MITIGATION PLAN FINAL

Bridgefork Dairy Mitigation Site

Re: NCIRT Review and USACE Approval of the NCDMS Bridgefork Dairy Mitigation Site /
Cleveland County

The purpose of this letter is to provide the North Carolina Division of Mitigation Services (NCDMS) with all comments generated by the North Carolina Interagency Review Team (NCIRT) during the 30-day comment period for the Bridgefork Dairy Draft Mitigation Plan, which closed on August 20, 2022. These comments are attached for your review.

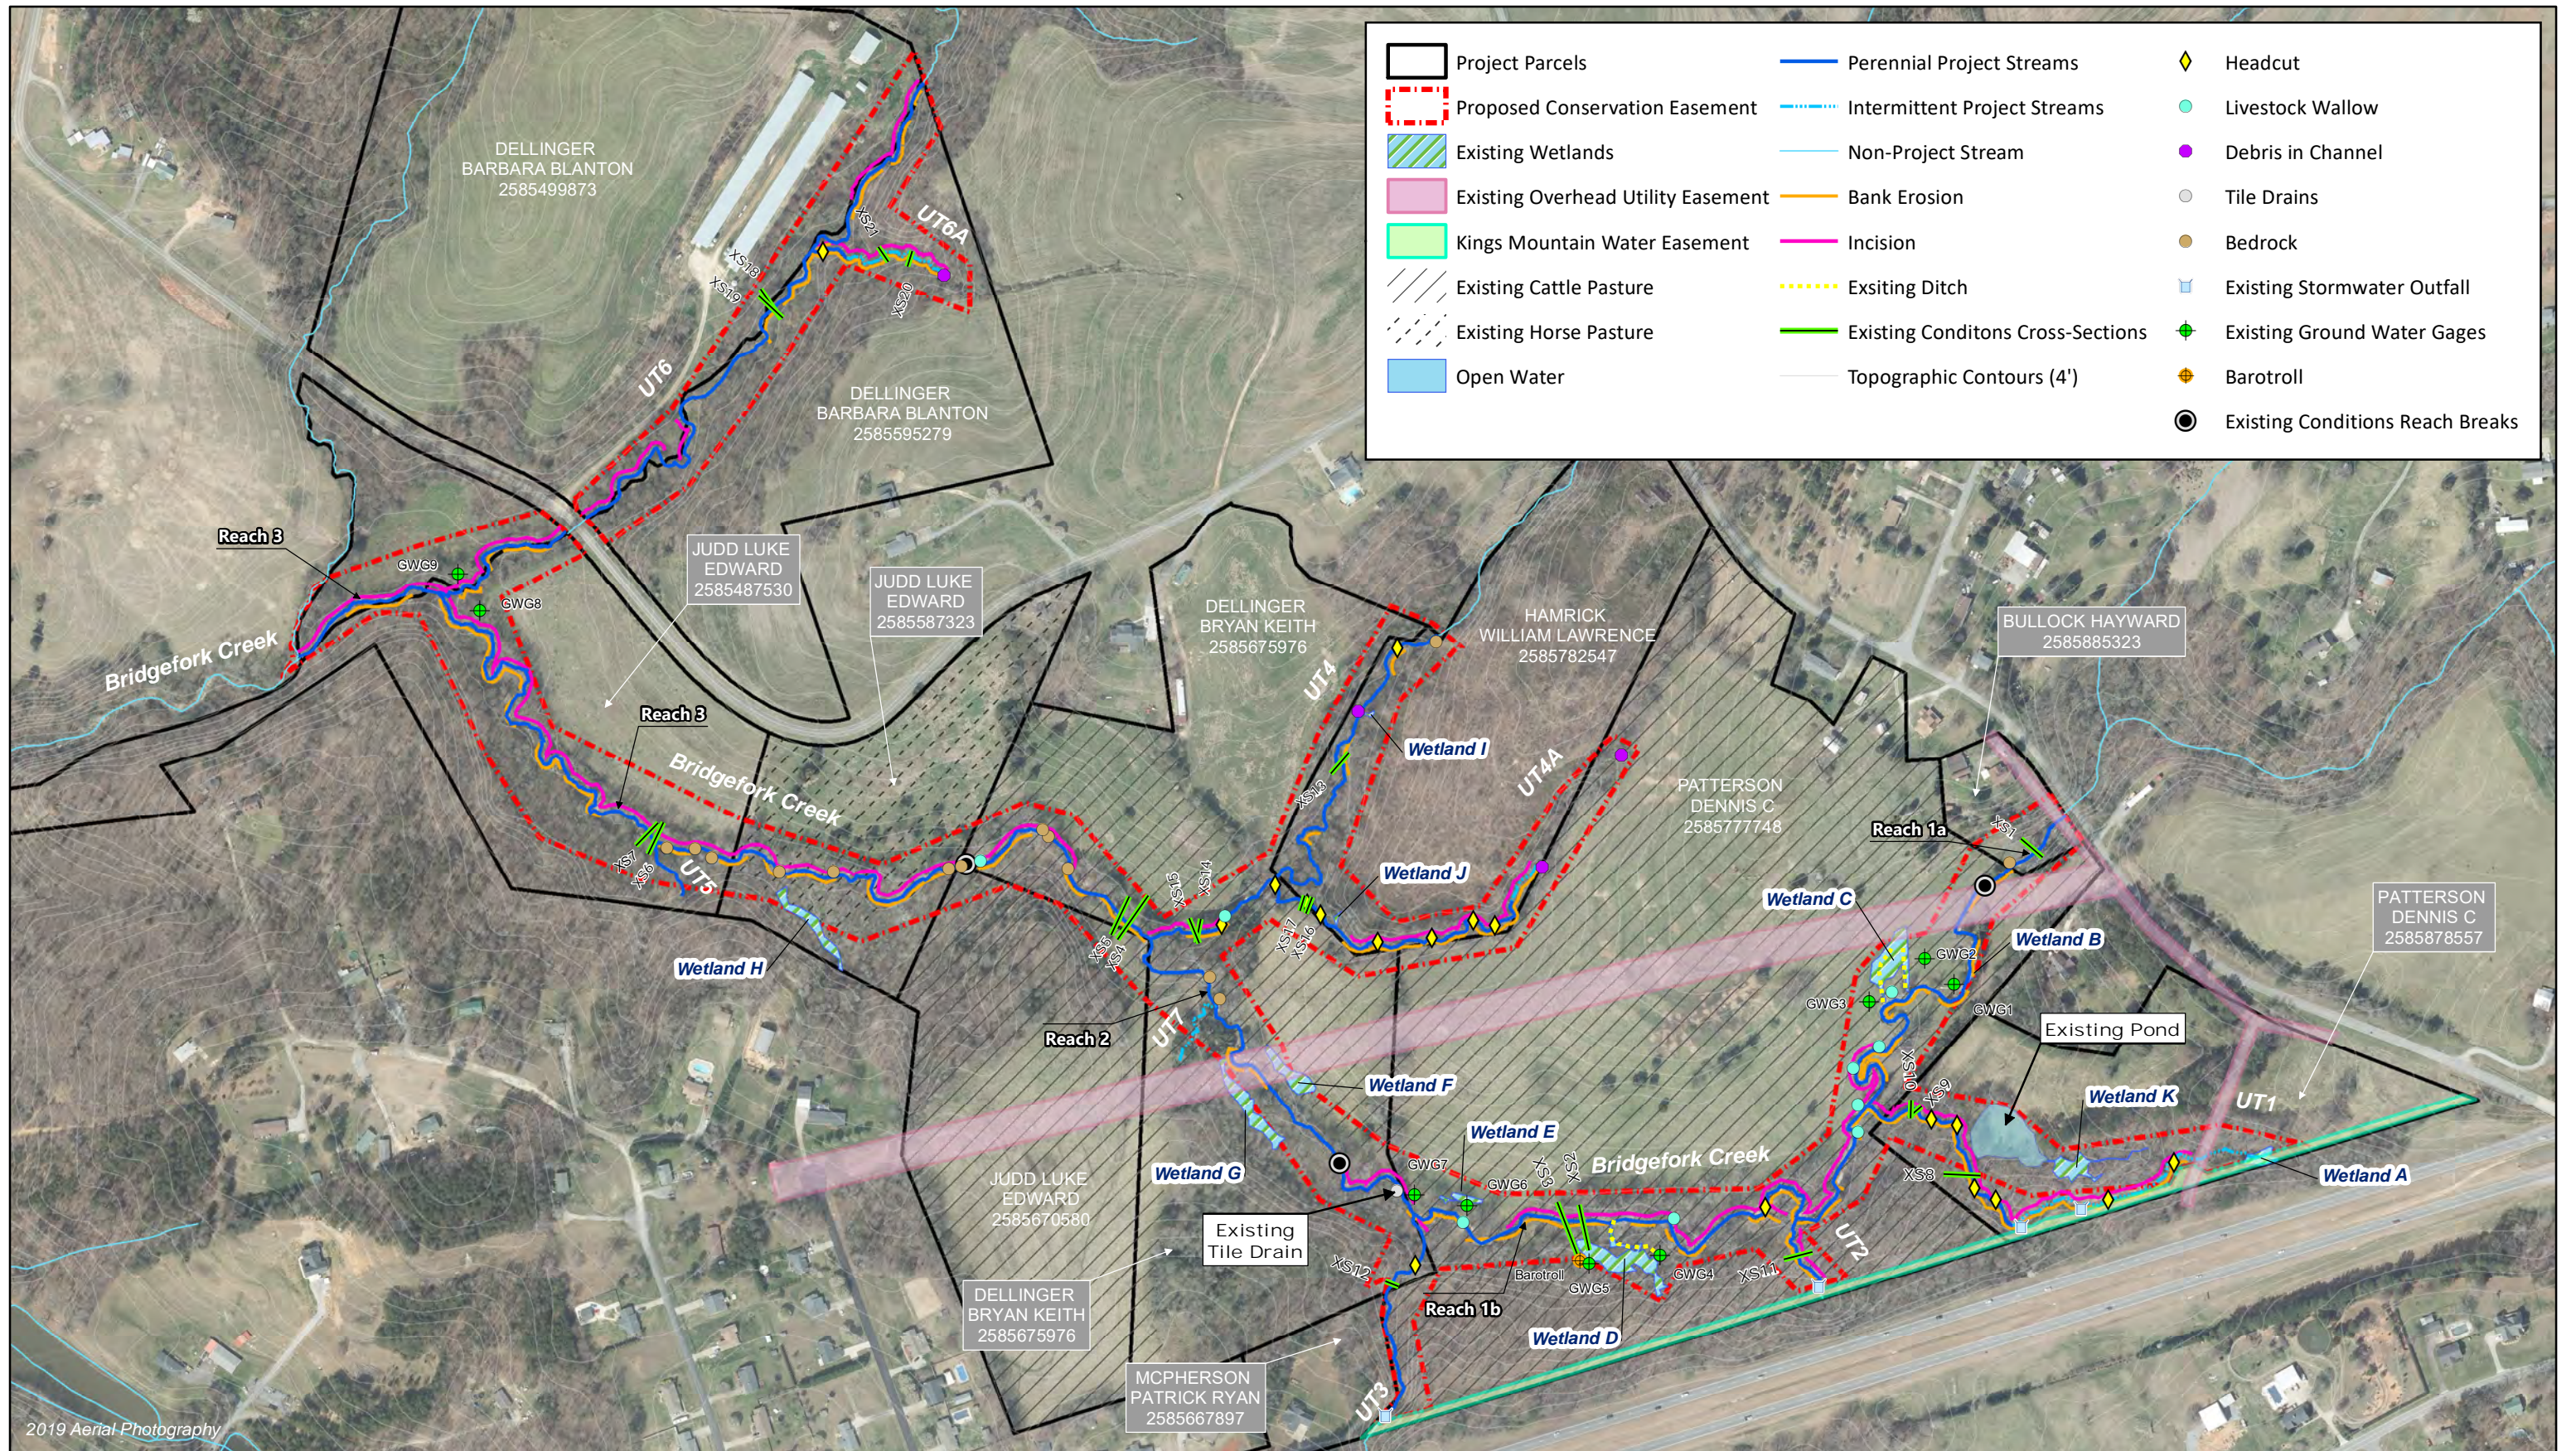
14. Page 34, Section 6.8.2 – Figure 2 shows three existing drainage ditches. Please add callouts to fill ditches on design sheets.
15. Page 35, Section 6.8.3 – Regarding the preliminary/detailed soil investigation, is the single soil profile provided representative of all nine proposed wetland credit areas? Why were no borings taken within proposed wetland rehab areas? Also, has a sampling effort or any investigation of the pond bottom sediments been performed?

22. General Comment – Please make sure to QAQC spelling, spacing, and formatting in the plan narrative.
23. Figures 2 & 10 – Have red box comments already been incorporated into the figures? In the future, DWR would appreciate figures at this scale and with this much detail to be saved/printed as 11x17.

- 14) Page 34, Section 6.8.2 – Figure 2 shows three existing drainage ditches. Please add callouts to fill ditches on design sheets.
- *Callouts to fill ditches have been added to plan sheets.*

- *Red box comments shown on Figure 2 and 10 were from a previous internal review and were removed from the figures.*
 - *Figures 2 and 10 are included as 11x17 exports within the report.*

- There are two GWG 8 shown and no GWG6.
 - Figure 2 was revised to correct the error.

Figure 8 Concept Design Map
 Bridgefork Dairy Mitigation Site
 Broad River Basin 03050105
 Cleveland County, NC

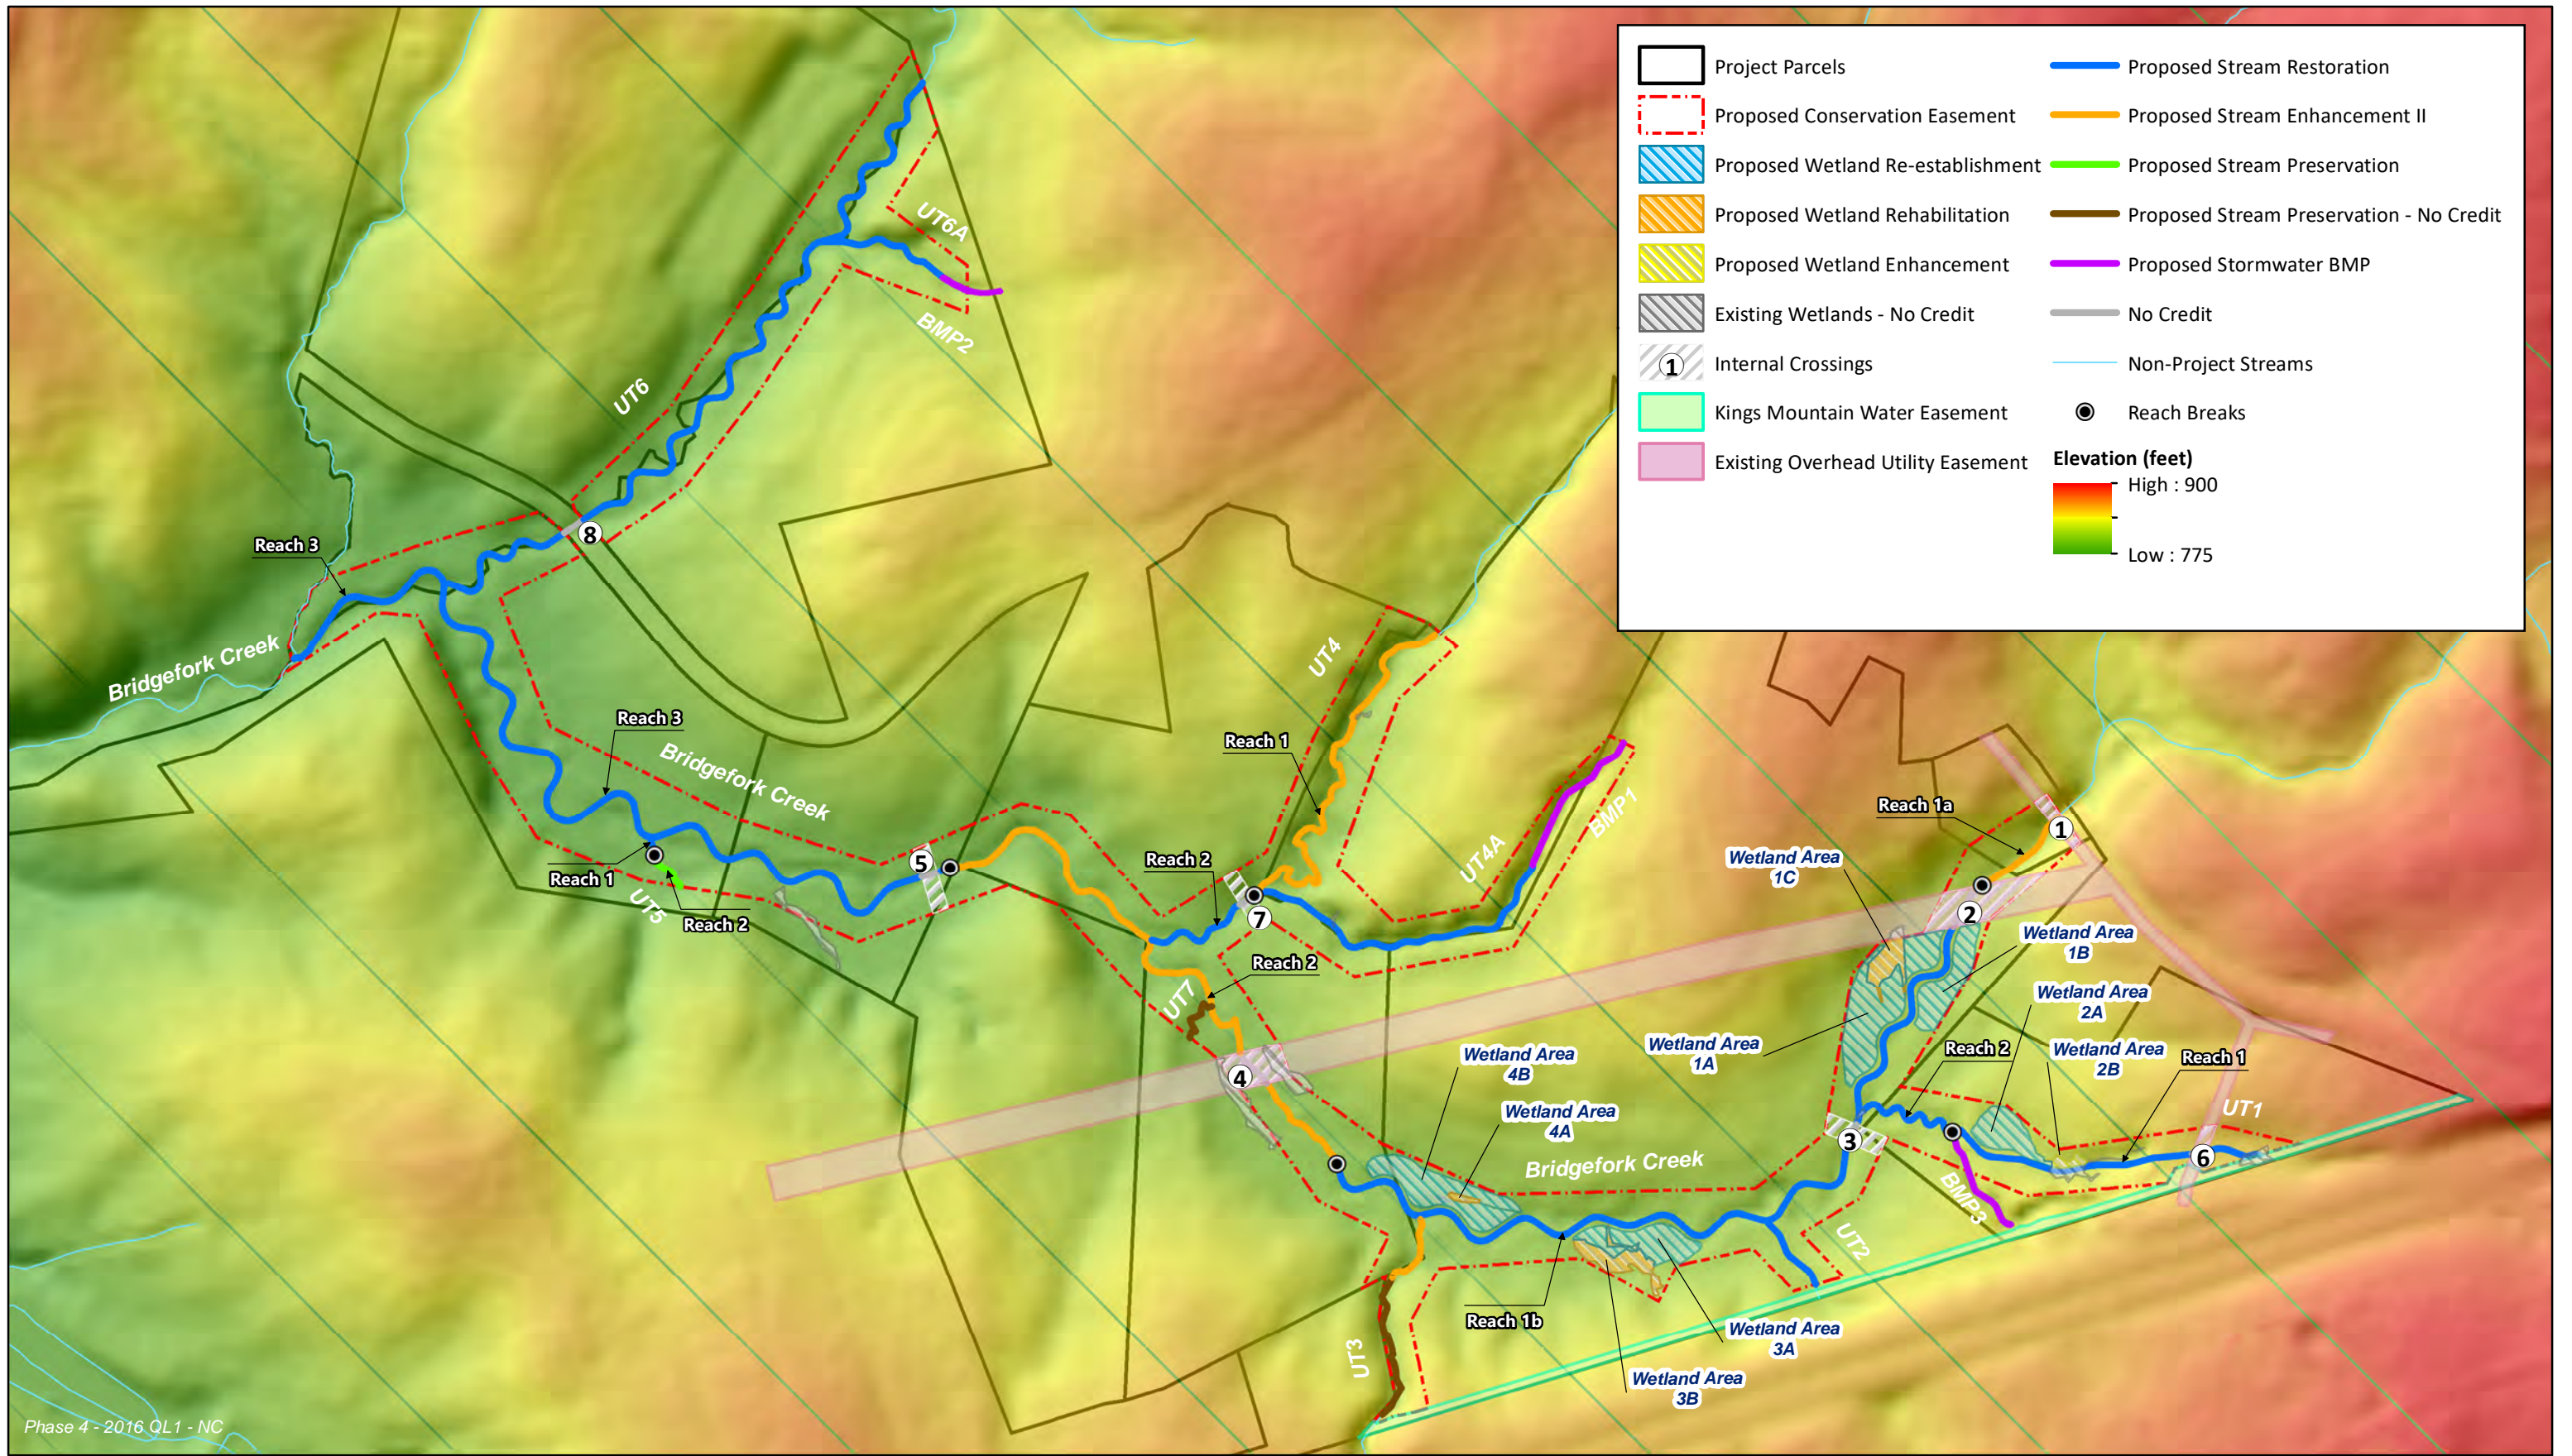
- UT5 appears to be shown as preservation only on these figures. Restoration reach may be too short to display correctly. Please verify.
- Figure 8 and 10 indicates a reach break on UT1; however, no break is indicated on the Project Credit Table or elsewhere in the report. Please update as necessary.

- UT5 appears to be shown as preservation only on these figures. Restoration reach may be too short to display correctly. Please verify.
 - Figures 8, 9, and 10 have been updated to show both reaches and approaches for UT5.
- Figure 8 and 10 indicates a reach break on UT1; however, no break is indicated on the Project Credit Table or elsewhere in the report. Please update as necessary.
 - UT1 is broken into two reaches throughout the report and figures, including Table 31, Figure 8, and Figure 10.

1.2.2

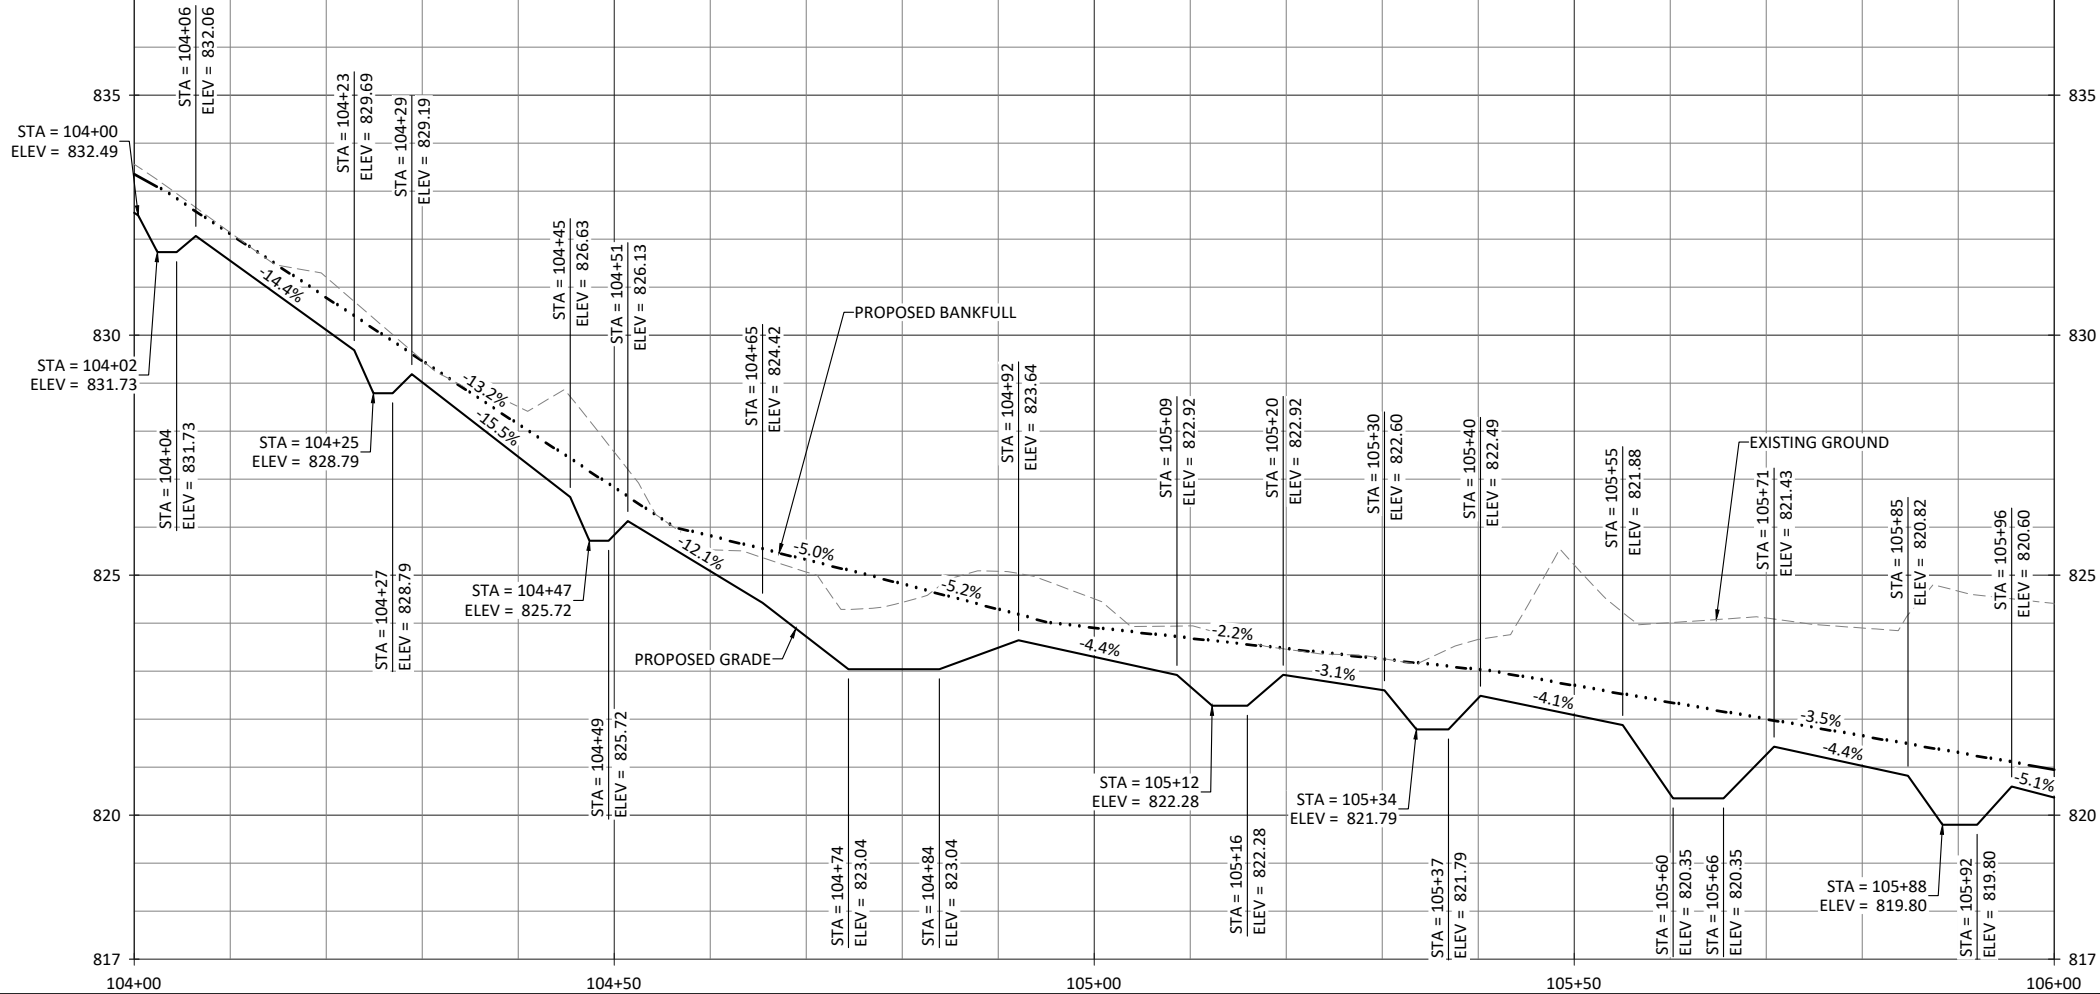
- Two “Proposed Shallow Vernal Pools” are shown on the plan (sheet 1.2.2 and 1.2.3) but not discussed. Please include a short discussion of these features. What is the expected depth, will they dry seasonally, maintenance, type of outlet: rip-rap, etc.
- Recommend referring the BMP in this discussion as BMP 3 as shown on sheet 1.2.5.
- Does WEI plan to bring in new material to construct the channel through pond bottom? Please add discussion.

- *Two “Proposed Shallow Vernal Pools” are shown on the plan (sheet 1.2.2 and 1.2.3) but not discussed. Please include a short discussion of these features. What is the expected depth, will they dry seasonally, maintenance, type of outlet: rip-rap, etc.*
